Office Action Summary

09/822,175

YANAGAWA ET AL.

DETAILED ACTION

FIG. 12A**FIG. 12B**

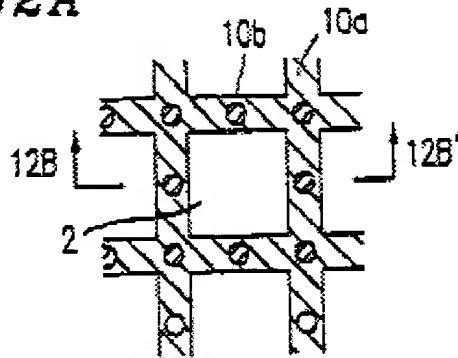
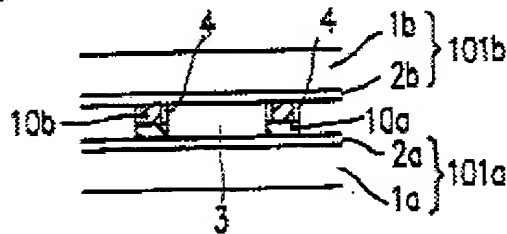
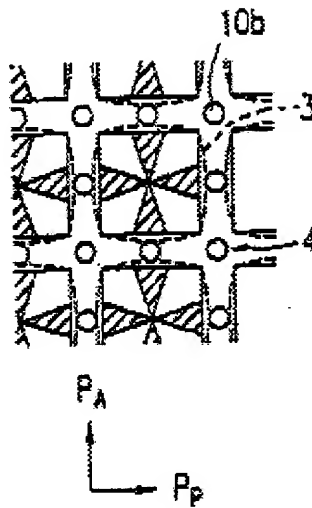
As to claim 35, Onishi discloses in Figures 12A-12C a liquid crystal display device of Example 1 (col. 17, line 60 through col. 33, line 34; especially col. 31, line 1 through col. 33, line 34) comprising a pair of substrates, 1a and 1b, as disposed to spatially oppose each other with a layer of liquid crystal material interposed therebetween and a seal material, 4, used for adhesion of one of the substrates to a remaining substrate, said seal material also having a function of encapsulating the liquid crystal material, wherein

a plurality of photolithographically formed (col. 31, lines 25-32) projection bodies, 10b, are precisely dispersed on one of said substrates in a predetermined shape thereof

at a desired location thereon, and then said seal material is formed on said one of said substrates to bury said projection bodies therewithin (as illustrated in Figure 12B) (see also masks illustrated in Figures 11 and 13).

As to claim 36, Onishi discloses in Figures 12A-12C a liquid crystal display device of Example 1 (col. through col. 33, line 34) the liquid crystal display device as recited in claim 36, wherein said plurality projection bodies are parallel-disposed (columns are parallel to each other and rows are parallel to each other, per Figure 12C).
